**Catawba
Nuclear Station
(CNS)**

Duke Energy ERO Standardization

TSC/OSC ERO Position Comparison and Evaluation

Revision 0

Standard TSC Organization

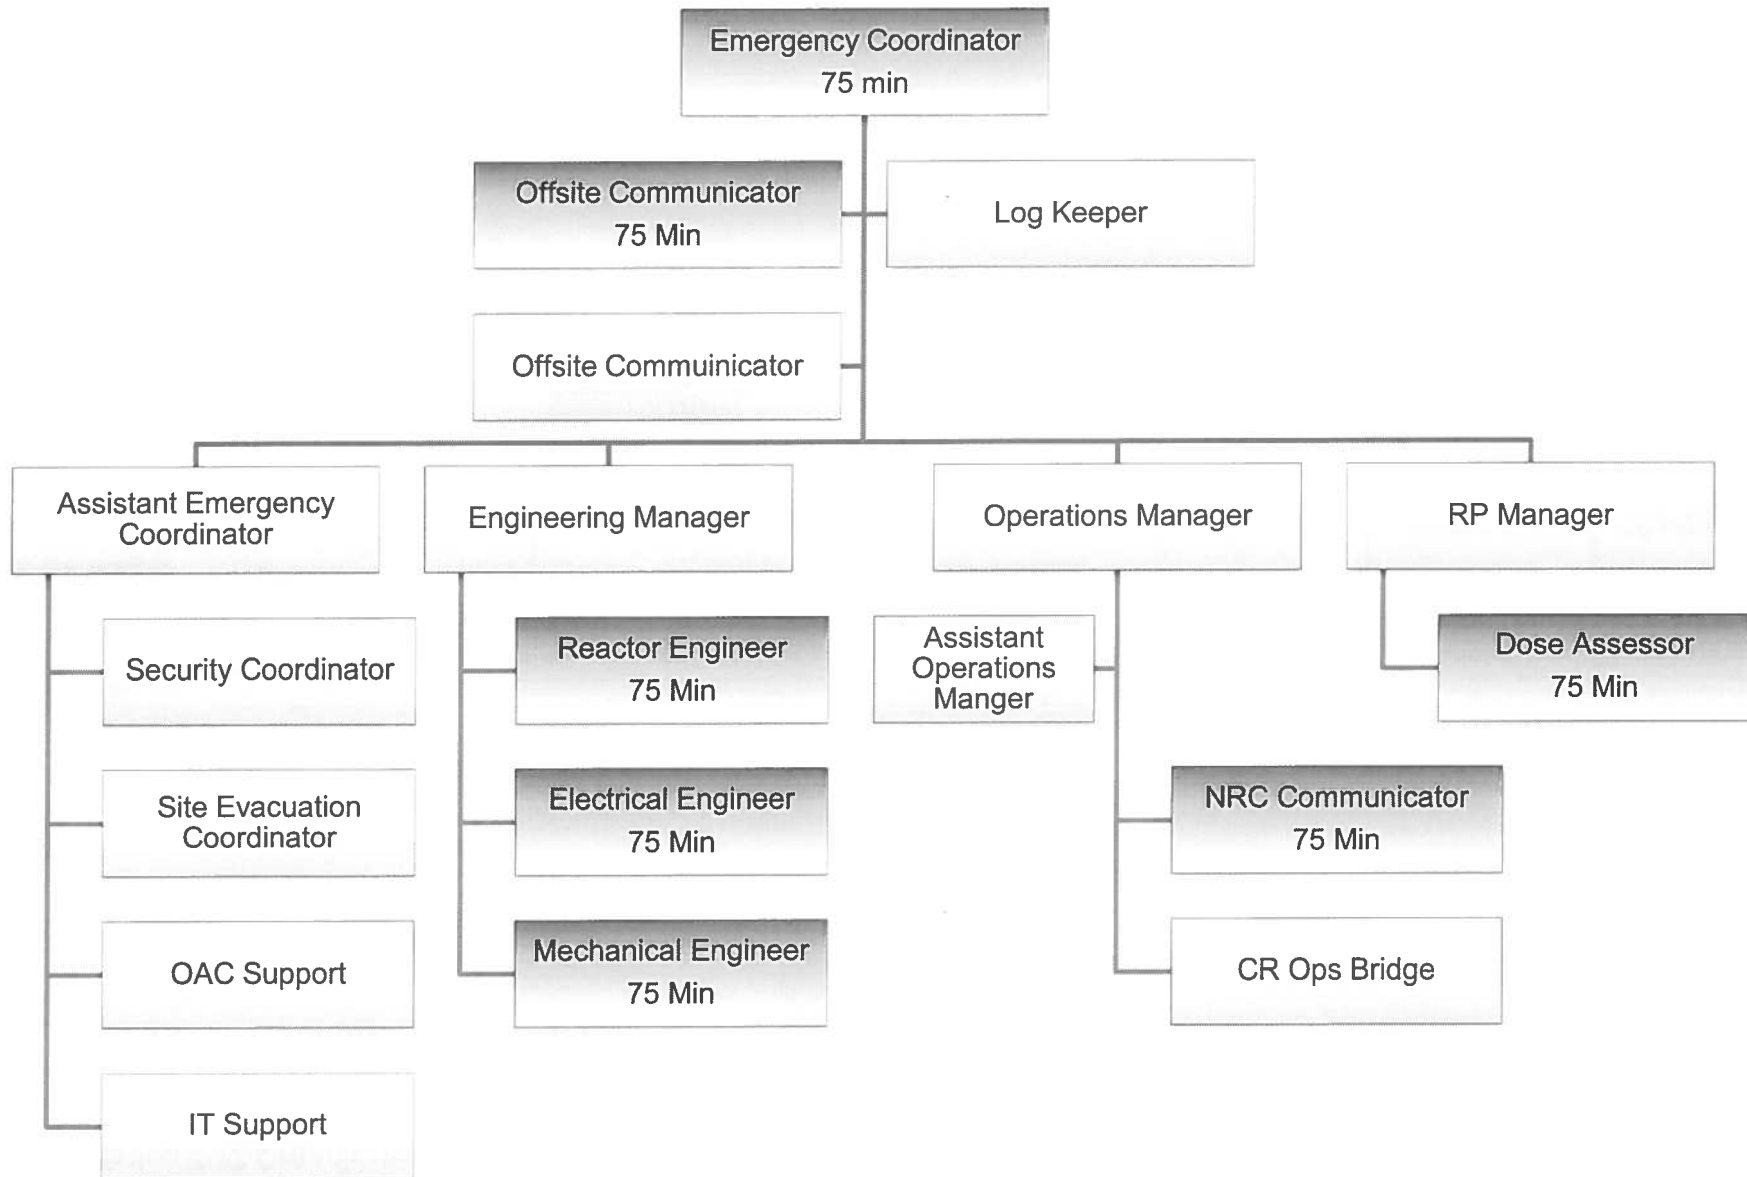
1.2.1. **TSC** – The TSC ERO staffing numbers remain at 19:

- 1) TSC IT Support was added (+1)
- 2) Electrical Engineer (moved from OSC) (+1)
- 3) Emergency Planner was removed (-1)
- 4) Assistant Operations Engineer was removed (-1)

Standard OSC Organization

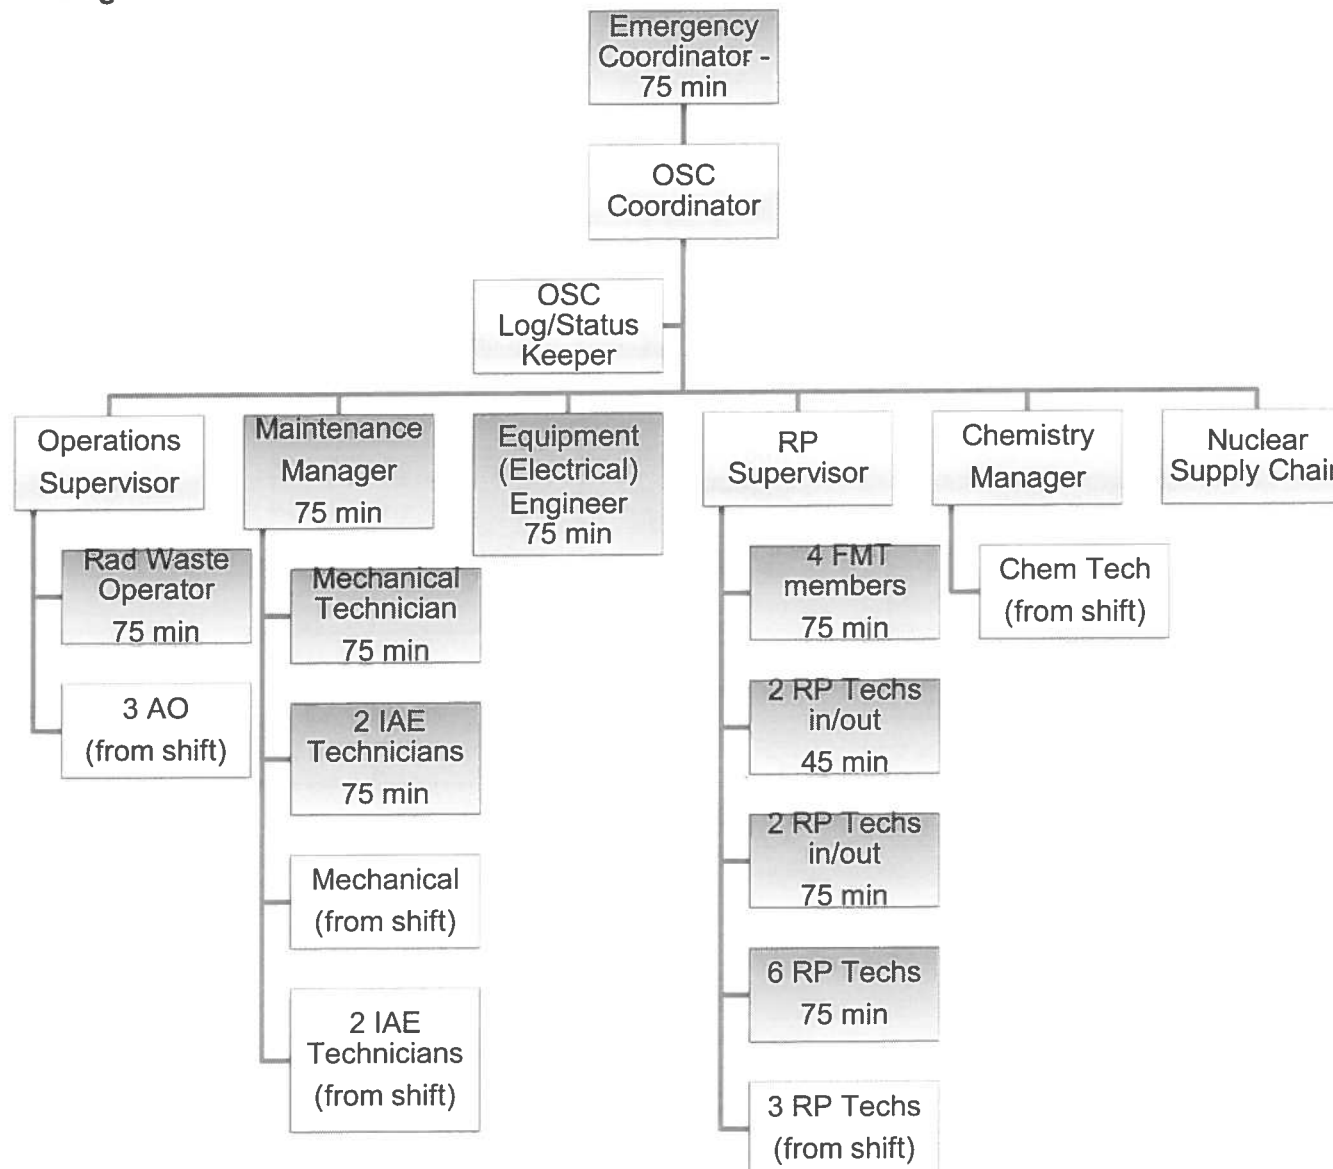
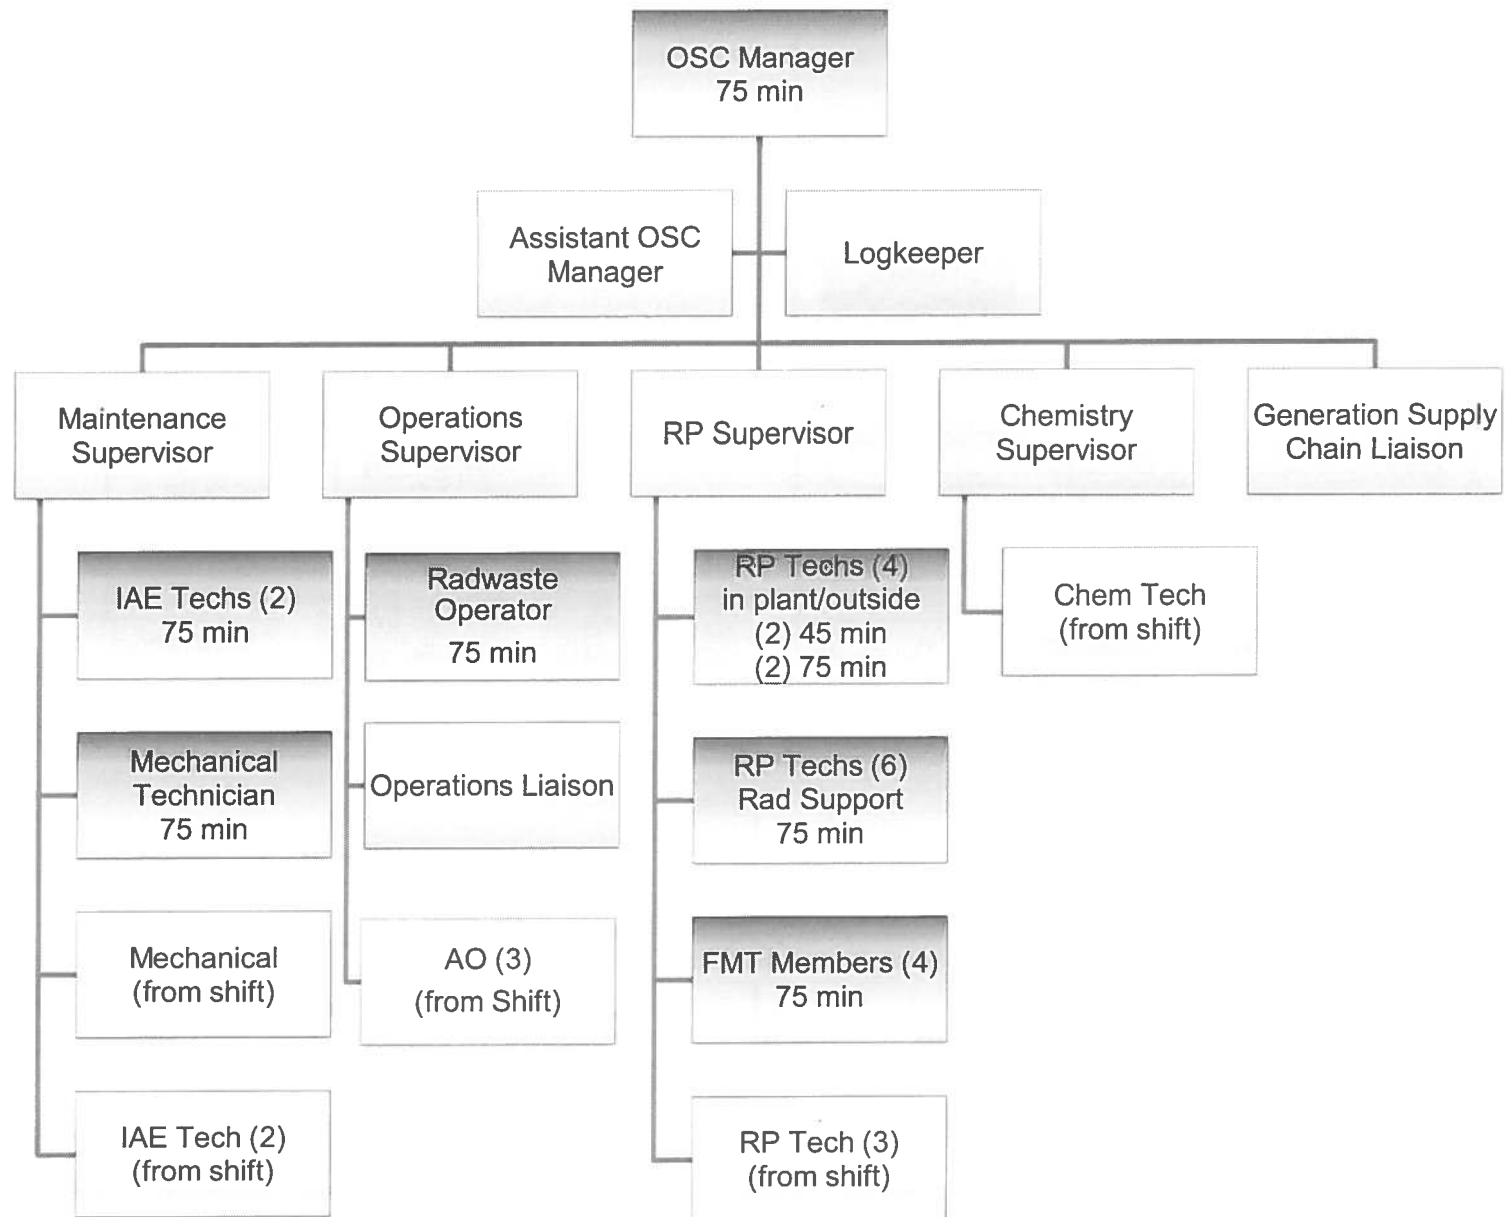
1.2.2. **OSC** – The OSC ERO staffing numbers remain at 27:

- 1) Assistant OSC Manager was added (+1)
- 2) OSC Operations Liaison was added (+1)
- 3) DRC Supervisor was removed (-1)
- 4) Equipment (Electrical) Engineer (moved to the TSC) (-1)

Standard EOF Organization

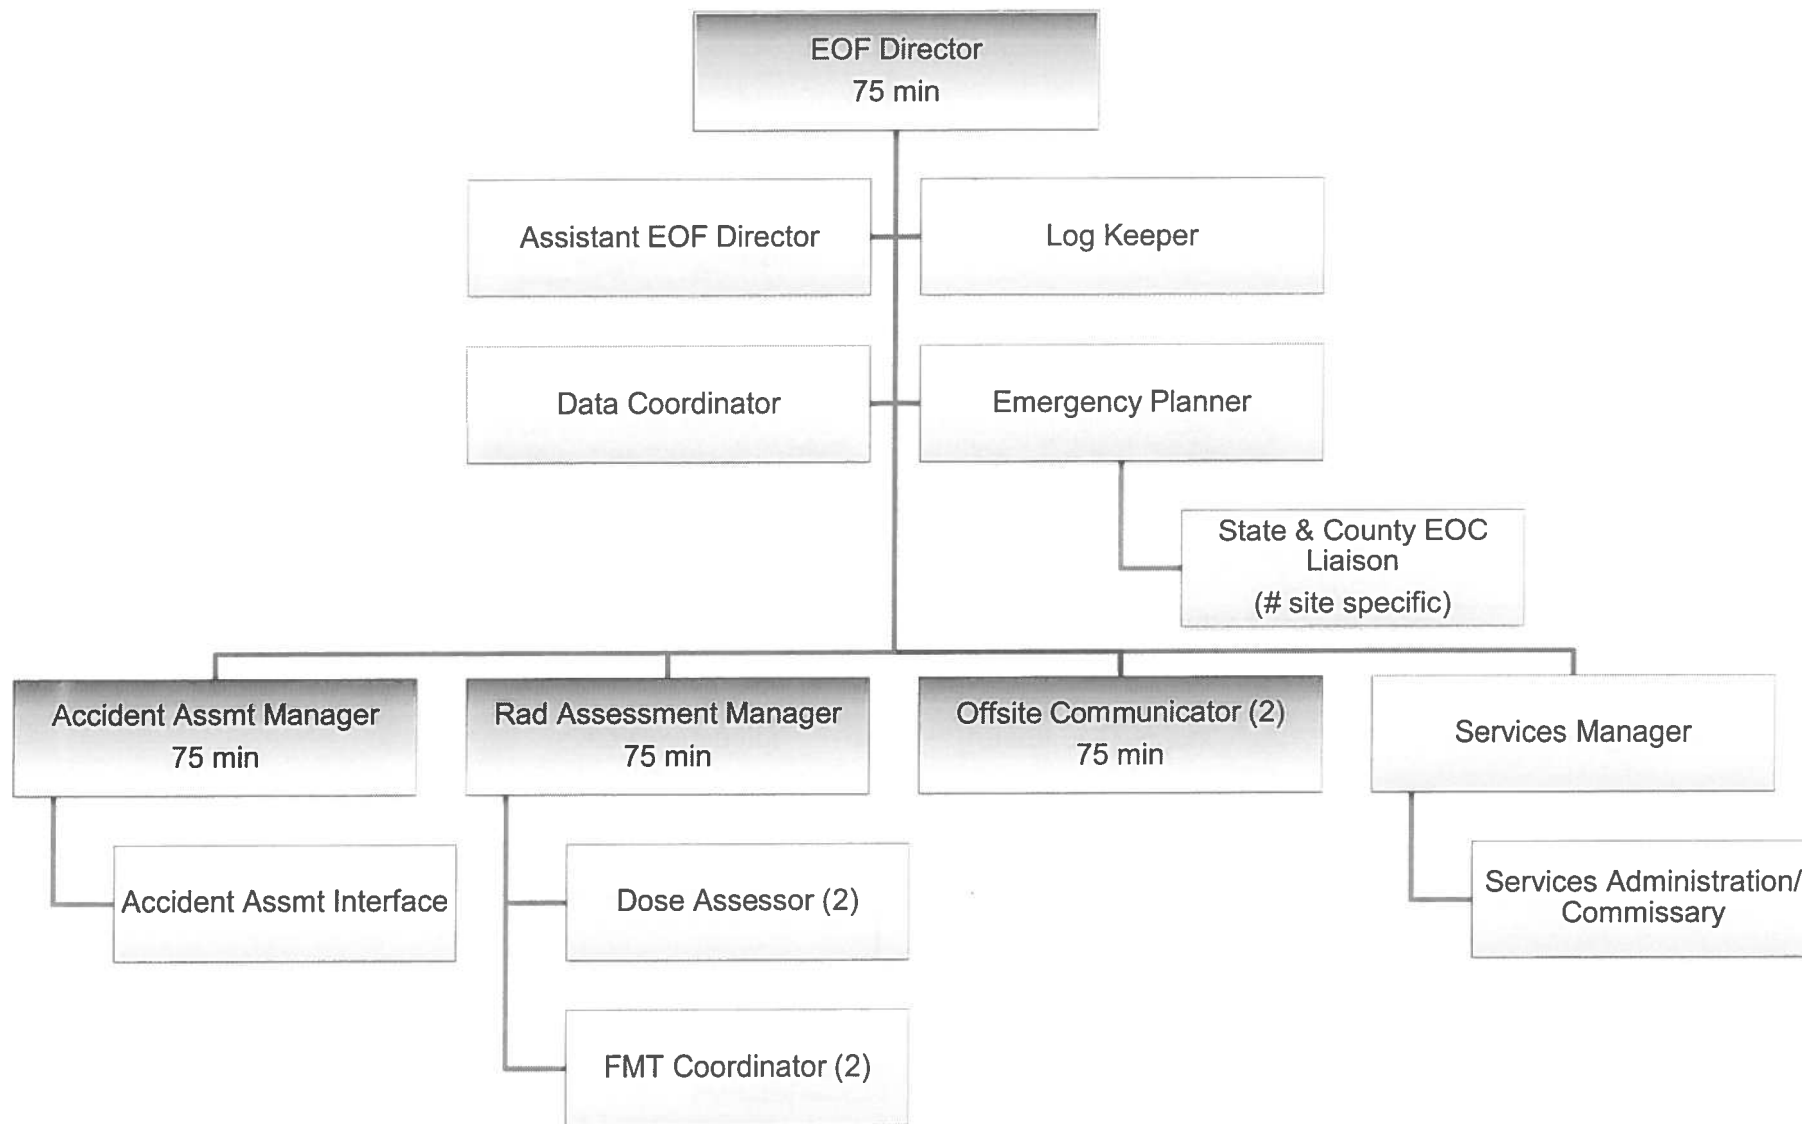
- 2.2. Full Staffing: The current augmented EOF ERO has eleven (11) full staff responders and the standard augmented ERO has eleven (11) full staff responders (no difference).

2.2.1. One (1) responder is moved from 75 minute to full staff response (+1):

- Dose Assessor
